STAFF RECOMMENDATION 1207 Gartland Avenue September 21, 2016

Application: Demolition; New construction—detached accessory dwelling unit; Setback determination

District: Lockeland Springs-East End Neighborhood Conservation Zoning Overlay

Description of Project: Application is to demolish an existing outbuilding and to construct a detached accessory dwelling unit (DADU) at the rear of the lot. The structure requires a rear setback determination from twenty feet (20') to ten feet (10').

SITE PLAN

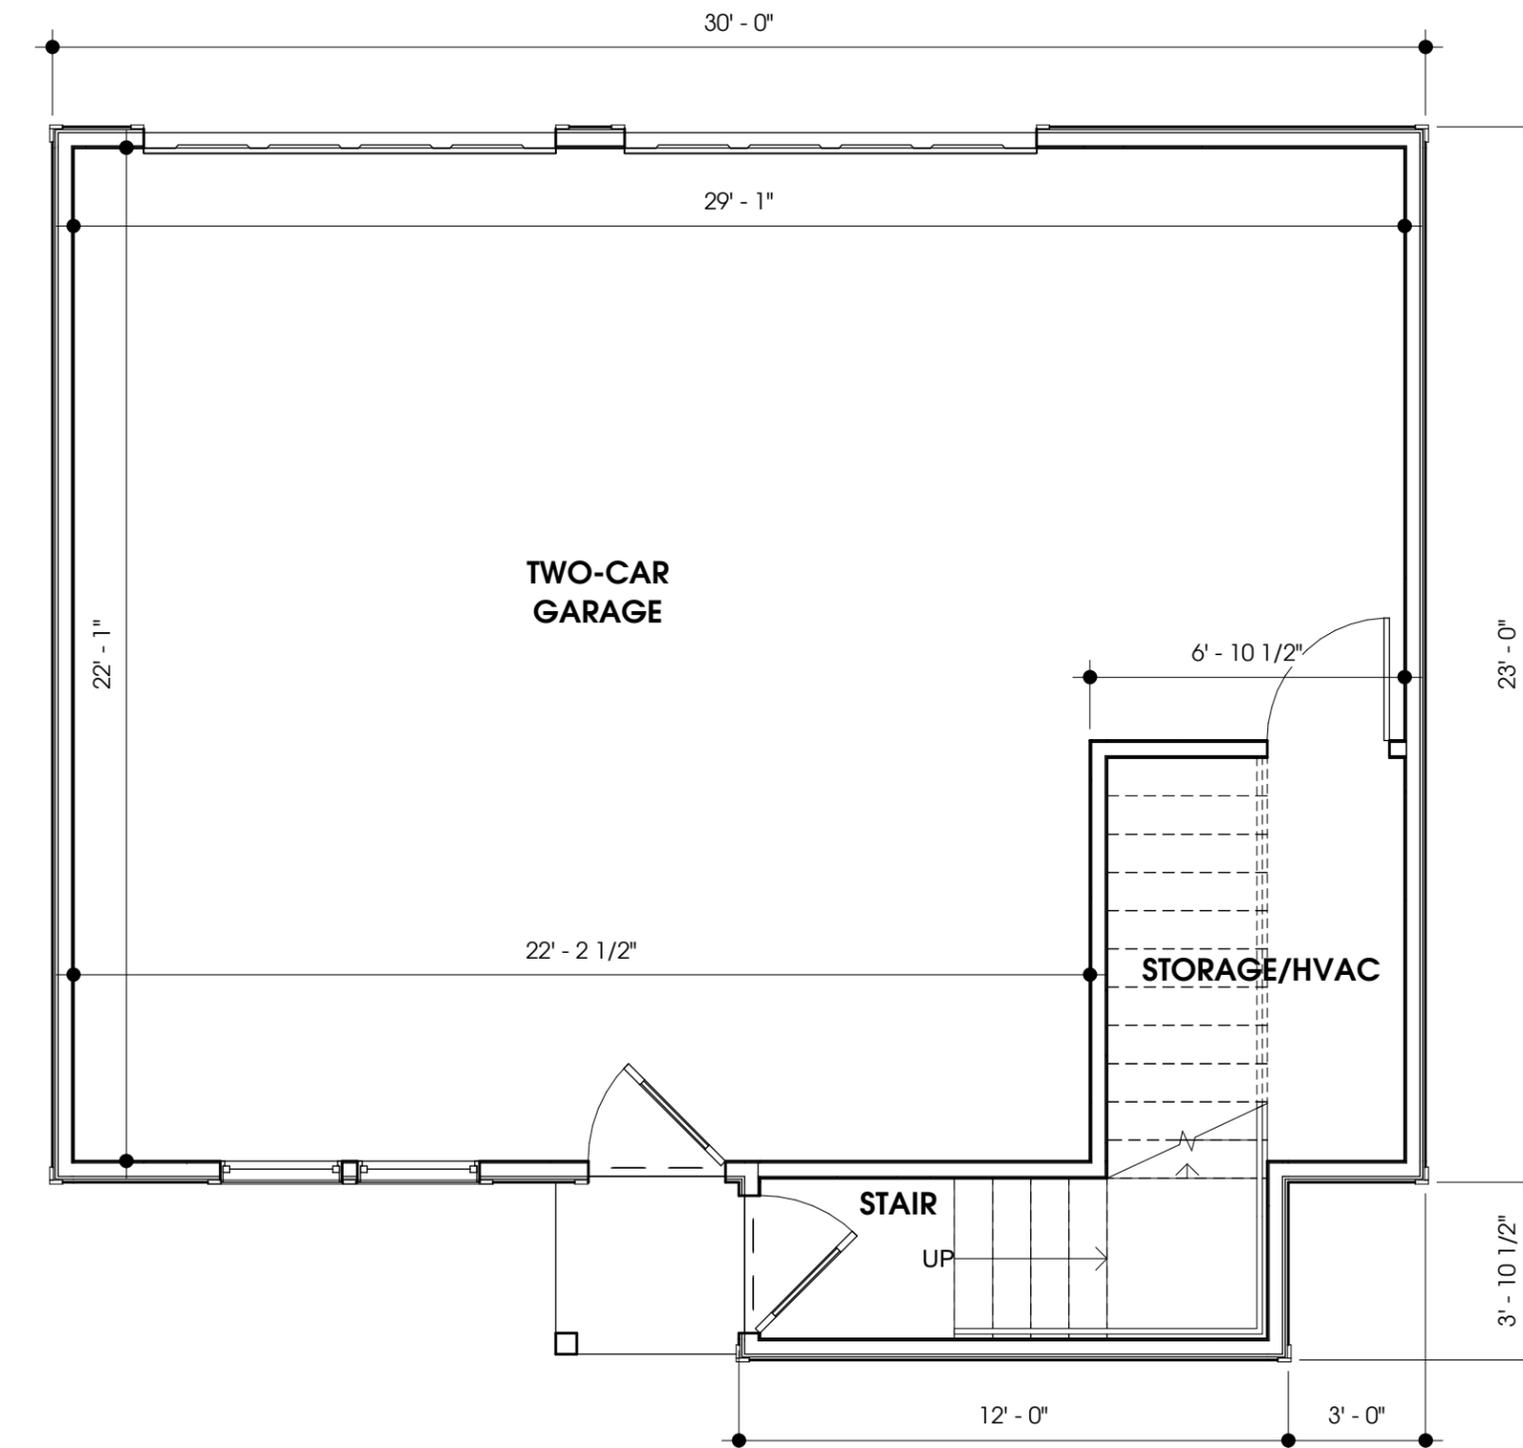
Setbacks: The new DADU does require a rear setback determination. When an outbuilding has a footprint greater than seven hundred square feet (700 sq. ft.), base

zoning requires that the structure be located twenty feet (20') from the rear property line and five feet (5') from the side property lines. In this instance, the structure is located at least five feet (5') from the side property lines, but it is located ten feet (10') from the rear property line. Staff finds that the proposed rear setback is appropriate because a ten foot (10') setback is the standard rear setback for structures that are seven hundred square feet (700 sq. ft.) or less. Also, historically, outbuildings were located at the rear of the property, close to the rear property line. A ten foot (10') rear setback is more historically appropriate than a twenty foot (20') rear setback. In addition, the ten foot (10') rear setback allows for more space between the primary structure and the outbuilding. Staff recommends approval of the setback determination.

MINIMUM	PROPOSED
Space between principal building and DADU/Garage	20'	36'
Rear setback	20'	10'
L side setback**	5'	13'
R side setback**	5'	5'
How is the building accessed?	From the alley or existing curb cut	Alley

The project meets Section II.B.8. of the design guidelines and 17.16.030.G. 4 of the ordinance.

ELEVATIONS

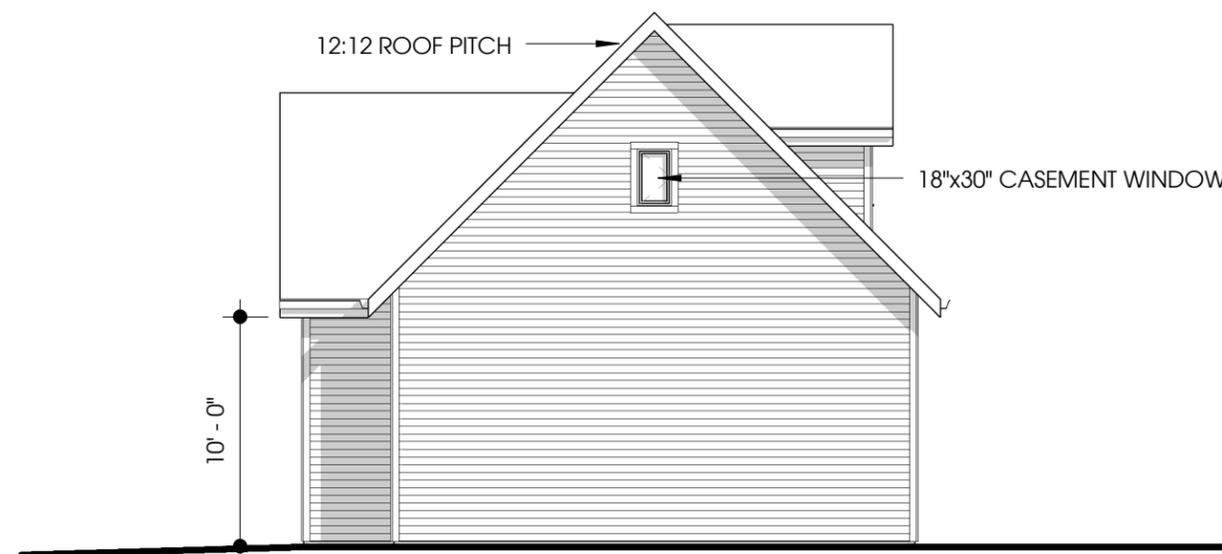
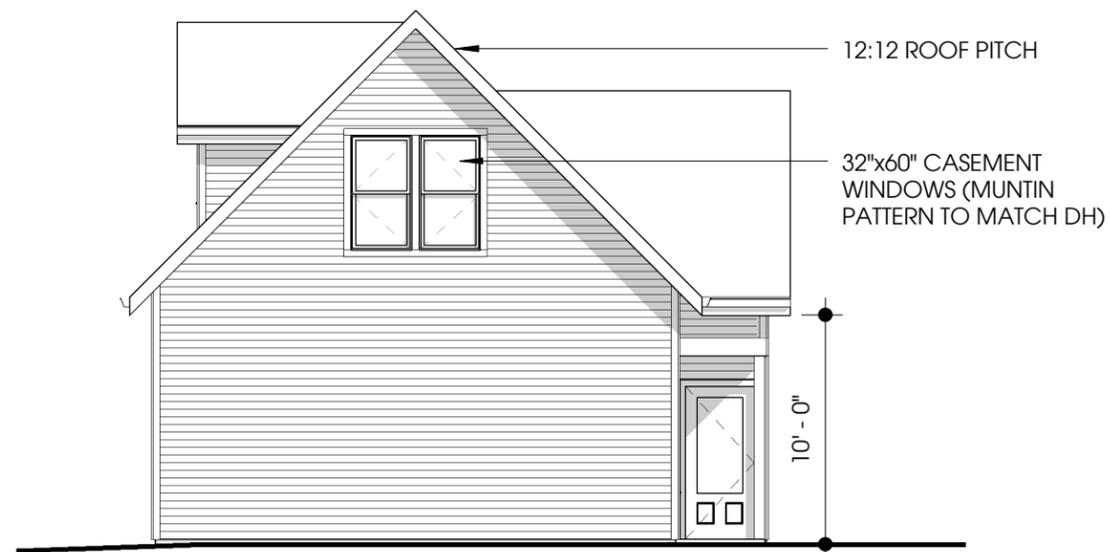
Roof Shape:

Proposed Element	Proposed Form	Typical of district?
Primary form	Cross-gable	X
Primary roof slope	12/12	X
Porch form	n/a	n/a
Porch slope	n/a	n/a

The accessory structure has a simple, utilitarian design that is appropriate for outbuildings. Its roof form, detailing, and form do not contrast greatly with the primary structure. As designed, the windows meet the standards of the design guidelines. In addition, the DADU is in a minimally-visible location at rear of the lot.

Proposed	Color/Texture	Approved Previously or Typical of Neighborhood
Foundation	Concrete slab	Natural color	X
Cladding	Cement-fiber	Smooth with 5" reveal	X
Roofing	Asphalt shingle	Needs final review	X
Trim	Cement fiber	smooth	X
Porch floor	Not indicated	Needs final review	
Porch Posts	Not indicated	Needs final review	
Windows	Not indicated	Needs final approval	
Pedestrian Door	Not indicated	Needs final approval	
Vehicular Door	Not indicated	Needs final approval

With the staff's final approval of the windows and doors and material information that has not yet been provided, staff finds that the known materials meet Section II.B.8.
